1. SUBMITTAL TYPE: (Is this a resubmittal? Yes ☐ No ☒)			
Deferred Submittal ☐	Addendum Number: 01	Revision Number:	CCD Number: Category A ☐ or B ☐
2. PROJECT INFORMATION:			
School District/Owner: San Beranrdo City USD		DSA File Number: 36 H7	
Project Name/School: Indian Springs HS - Health Center		DSA Application Number 04 123900

ADDENDUM NO. 1

Indian Springs High School – Health Center

DSA #04-123900 FILE #36-H7 RCA Project No. 1-78-50

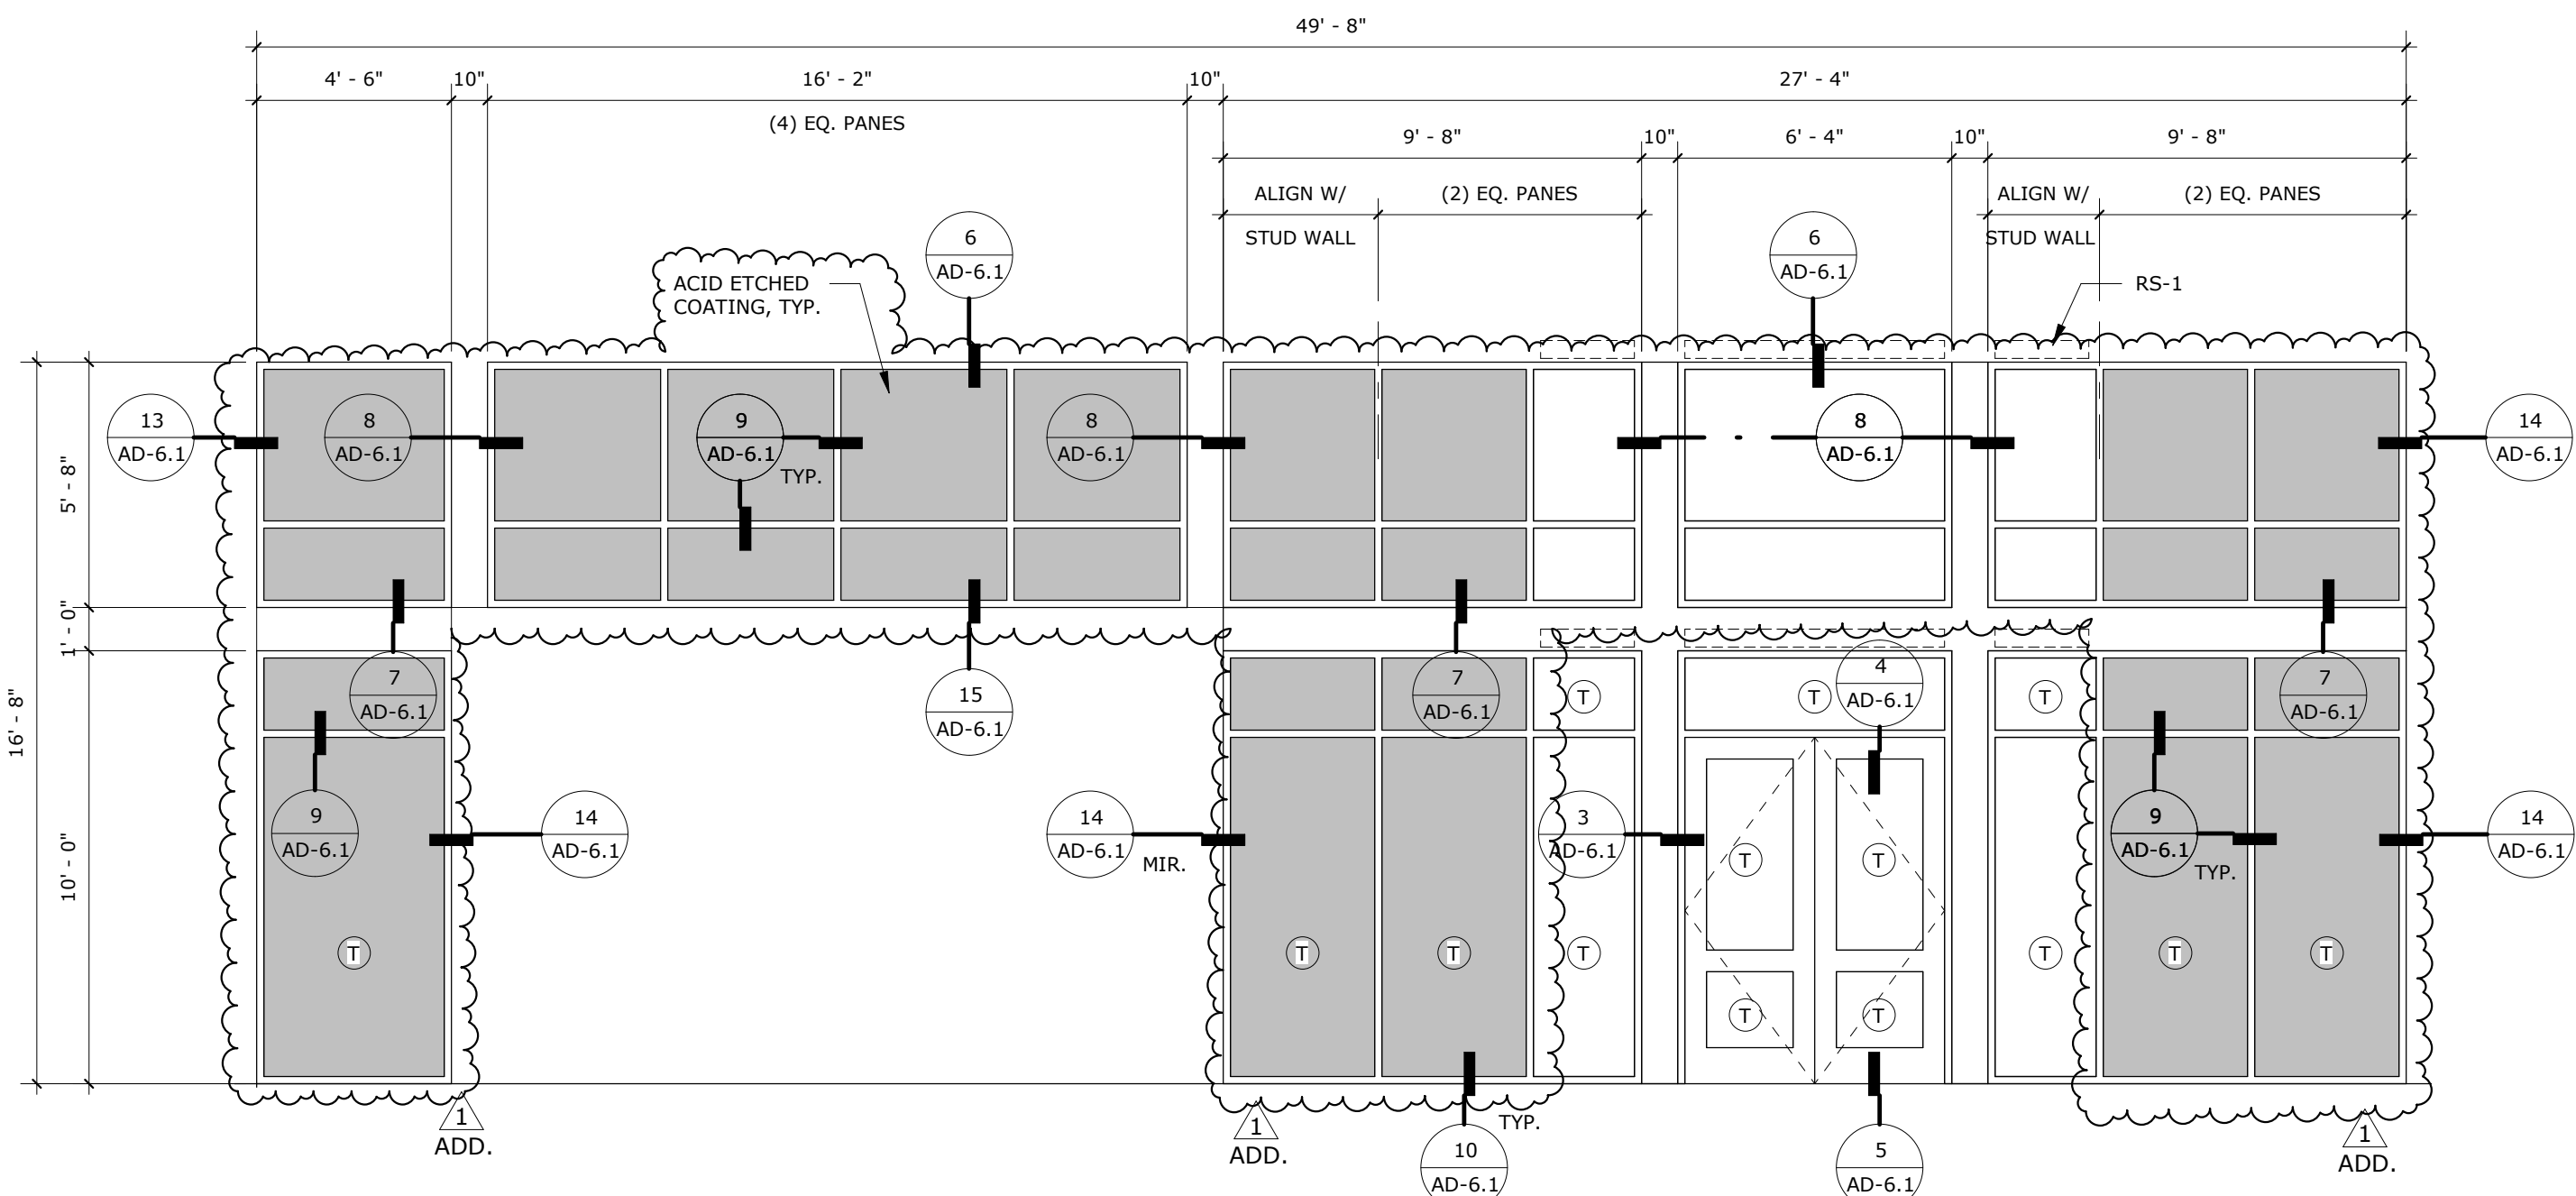
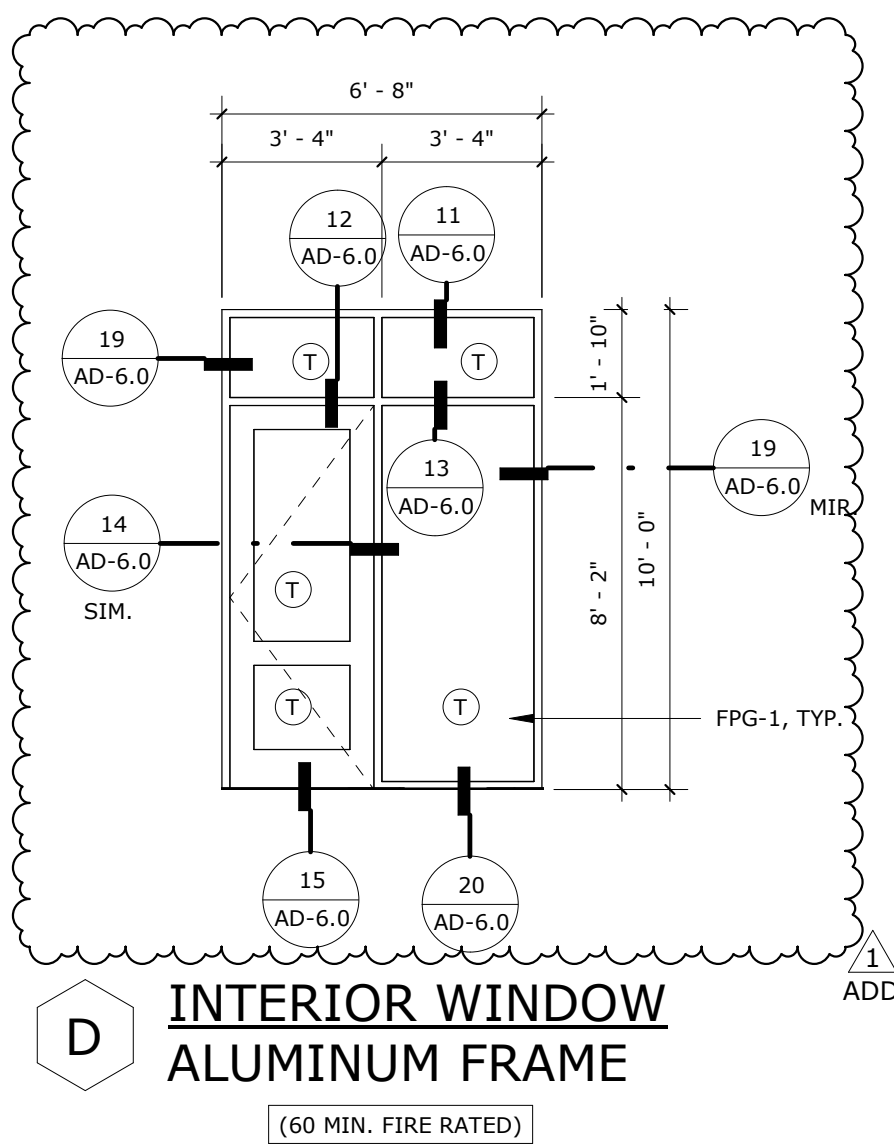
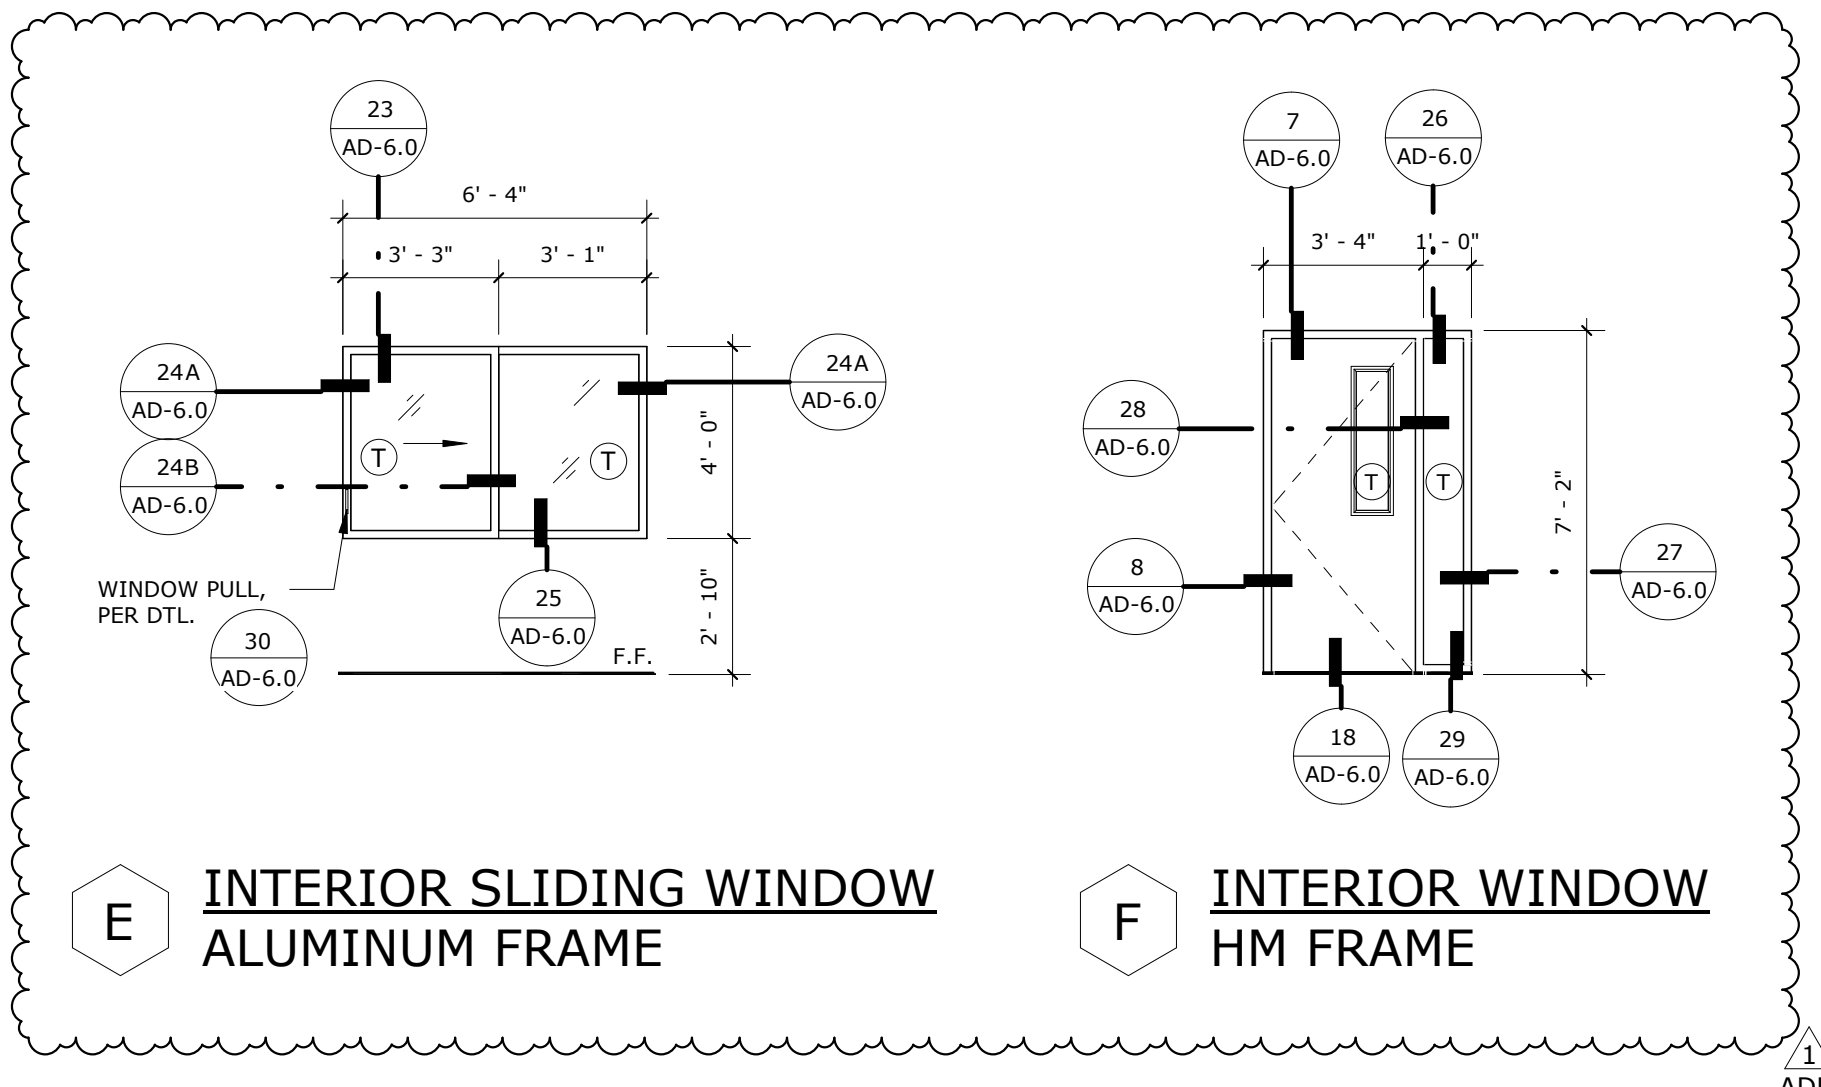
(b) Added New Detail 4
- Item No. 1.17 Reference Sheet A1-8.0 – DOOR & WINDOW SCHEDULE
1.17.1 Replace Sheet A1-8.0 and revise per clouded areas & items listed below:

(a) Door Schedule, revised finishes
 (b) Window Type A & C, revised glazing finish
 (c) Window Type D, reduced width to reflect floor plan layout
 (d) Added New Window Type E

(e) Added New Window Type F

COLORS, MATERIALS & FINISHES LEGEND

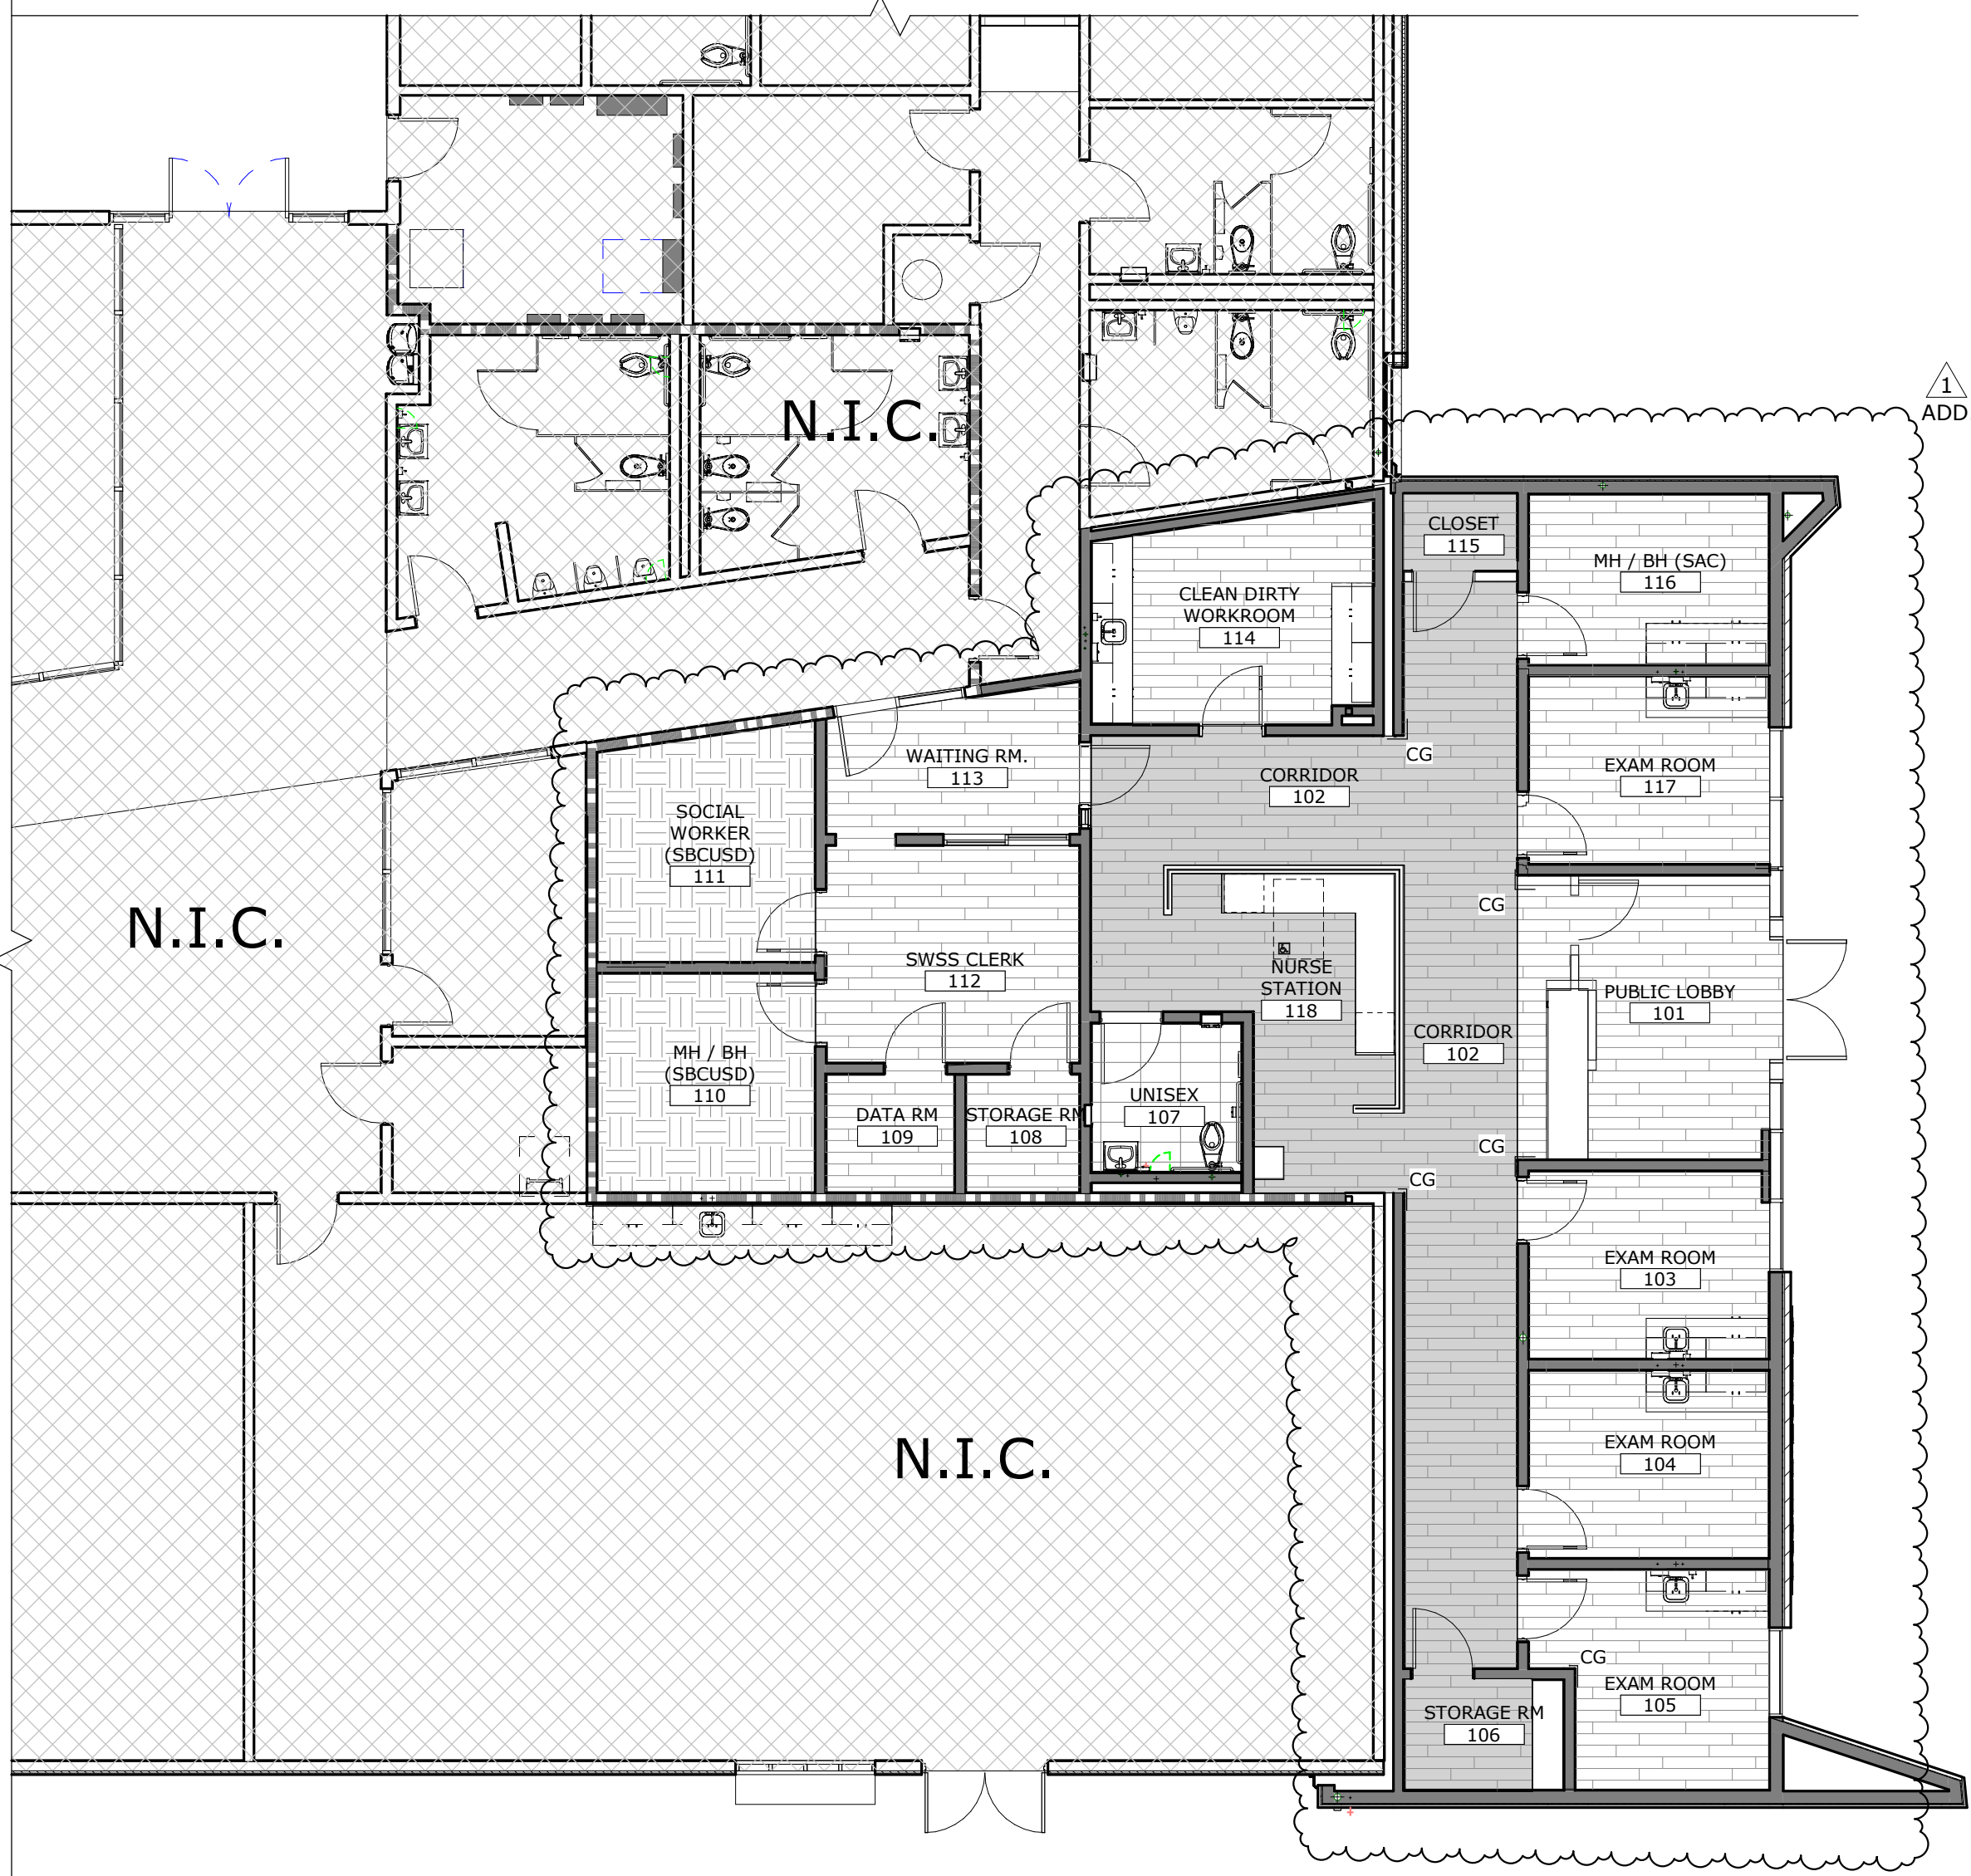
- Item No. 1.18 Reference Sheet ID-1.0 - FINISHES PLAN / SCHED & CMF LEGEND
- 1.18.1 Replace Sheet ID-1.0 and revise per clouded areas & items listed below:
- (a) Revised floor plan layout
 - (b) Revised Room Finish Schedule
 - (c) Revised C.M.F. Legend
